HALTON CONSERVATION COMMENTS

Proposed Burlington Quarry Expansion Interim JART COMMENT SUMMARY TABLE – Hydrogeology

Please accept the following as interim feedback from the Burlington Quarry Joint Agency Review Team (JART). Fully addressing each comment below will help expedite the potential for resolutions of the consolidated JART objections and individual agency objections. **These interim comments will be finalized following the breakout meetings between JART and Nelson and any changes will be marked using “track changes”.** Additional, new comments may be provided once a response has been prepared to the comments raised below and additional information provided.

Figure 10: Areas where average water levels will be restored (green cells) between P3456 and Deep Pond scenario. Remaining affected cells are shown in purple.

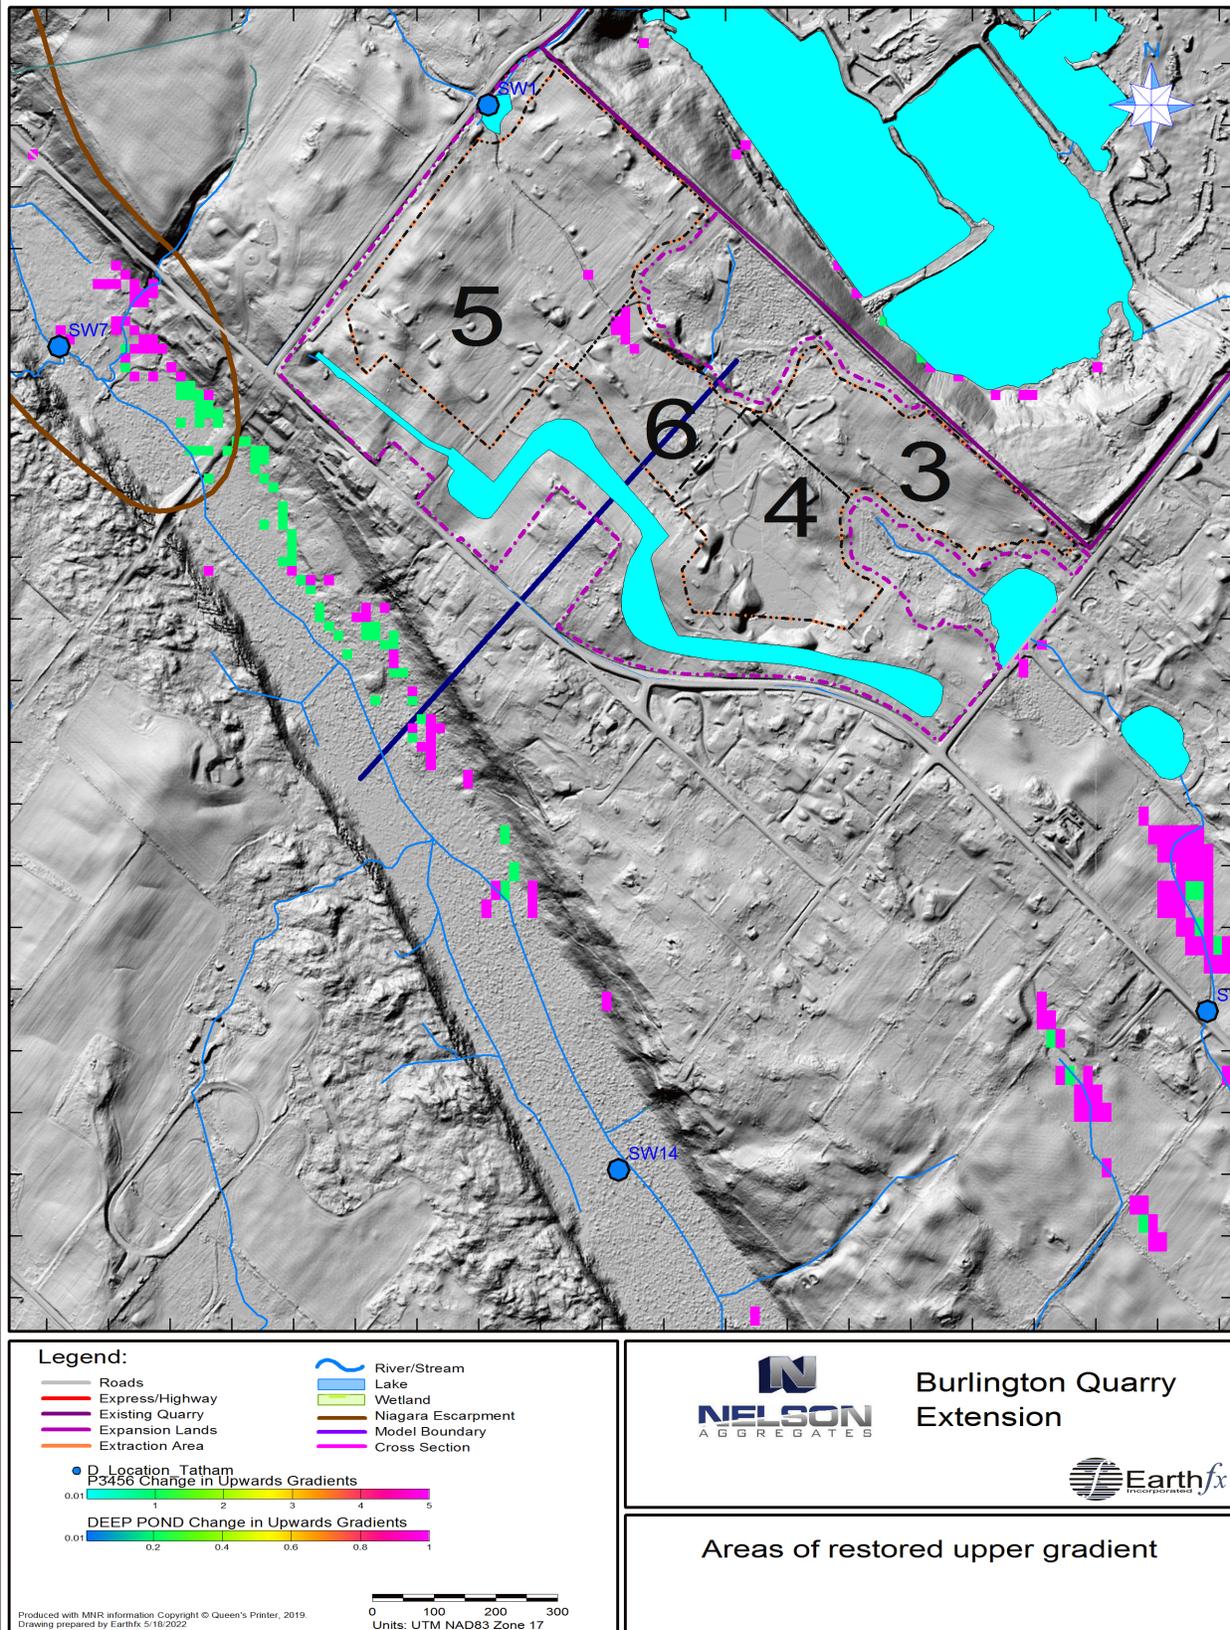
As in the previous scenario, the effects on the water levels and gradients in the Medad Valley were evaluated by identifying areas where there was a change in water level gradient. Areas where, on average, water levels in the Layer 4 bedrock will no longer be above ground surface are shown in Figure 9. These areas, shown as purple squares in Figure 9, are generally located along the eastern wall of the Medad Valley. Compared to the P3456 conditions shown in Figure 6, the affected area is reduced by over 50% and is now sporadically distributed along the eastern portion of the Medad valley (in areas of slightly higher local relief). Figure 10 compares the P3456 results to those of the Deep Pond scenario, showing the difference as green cells.
